Important U.S. Medical Device Removal

June 2021

Enhanced EMBLEM Electrode

Table 2. Users may distinguish affected/original EMBLEM Electrodes and the enhanced EMBLEM Electrodes through part number and packaging.

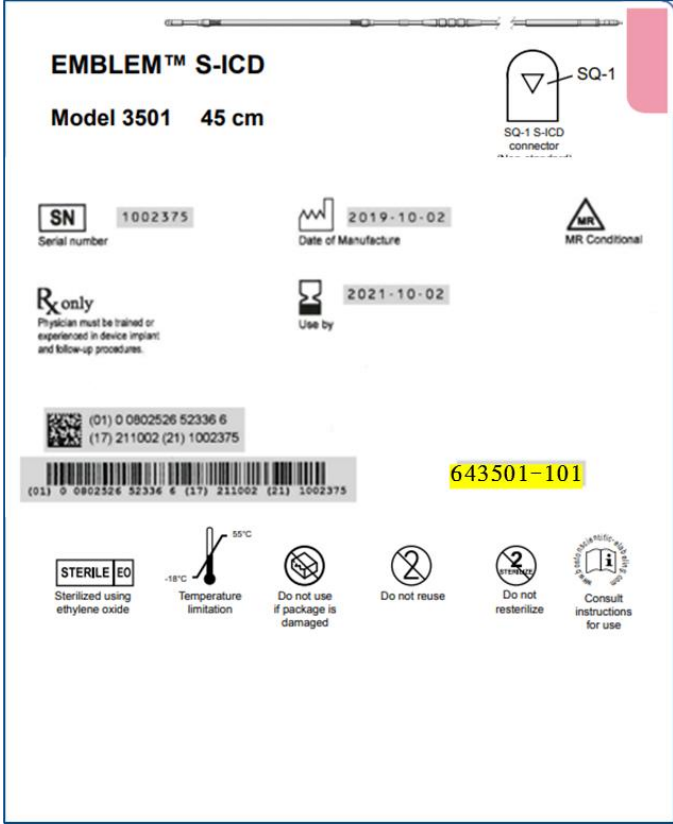
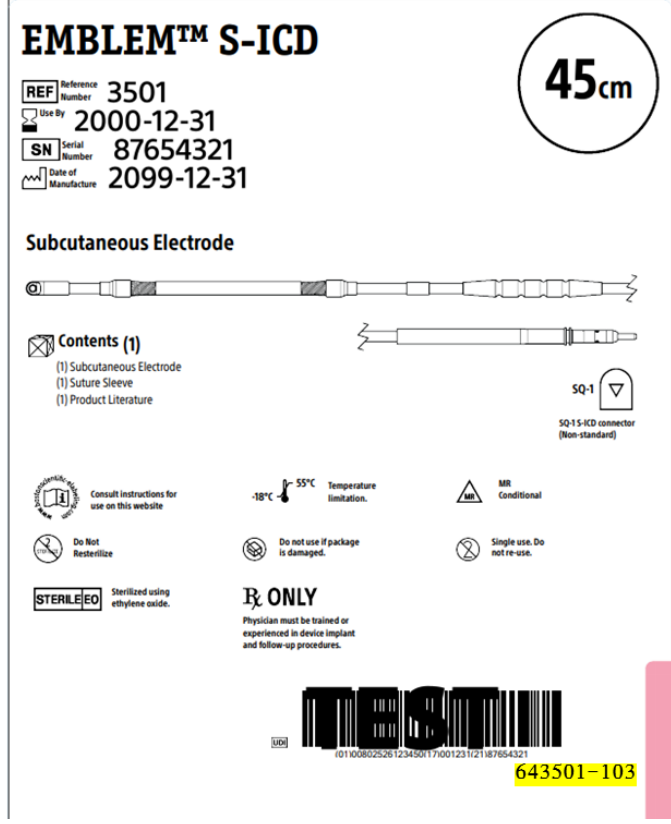
The root cause of body fracture for an affected/original EMBLEM Electrode is associated with the adhesive backfilled notch at a location distal to the proximal sense ring. This revealed notch facilitates connection of the sense conductor to the proximal sense ring. The enhanced electrode design has moved the connection of the sense conductor, notch, and adhesive to a centered location entirely under the sense ring. An accelerated, extreme laboratory test method was developed to assess electrode body fatigue around the sense ring using implant X-rays and body motion assessments. Based on this accelerated, extreme laboratory test, the enhanced EMBLEM Electrode design has demonstrated statistical survival of the electrode body around the sense ring to 10 implant years.

<p align="center">Remove and Return Affected/Original EMBLEM Electrode</p>	<p align="center">In Service Enhanced EMBLEM Electrode</p>
<p>When enhanced electrodes are available at your facility, return EMBLEM Electrodes with 9-digit part numbers ending in <u>0</u> or <u>1</u> (e.g., 643501-10<u>1</u> ends in <u>1</u> and is to be returned).</p> 	<p>Enhanced EMBLEM Electrodes include 9-digit part number ending in <u>3</u> or <u>higher</u> may be placed in service (e.g. 643501-10<u>3</u>, ends in <u>3</u>).</p> 
<p>The affected/original EMBLEM Electrode is potentially susceptible to electrode body fractures distal to the proximal sense ring. This packaging may also include literature describing the electrode body fracture behavior described in Dec 2020.</p>	<p>The enhanced version of the EMBLEM S-ICD Subcutaneous Electrode includes design enhancements to the proximal sense ring to address electrode body fractures distal to that location and changes to packaging for continued conformance with labeling requirements.</p>
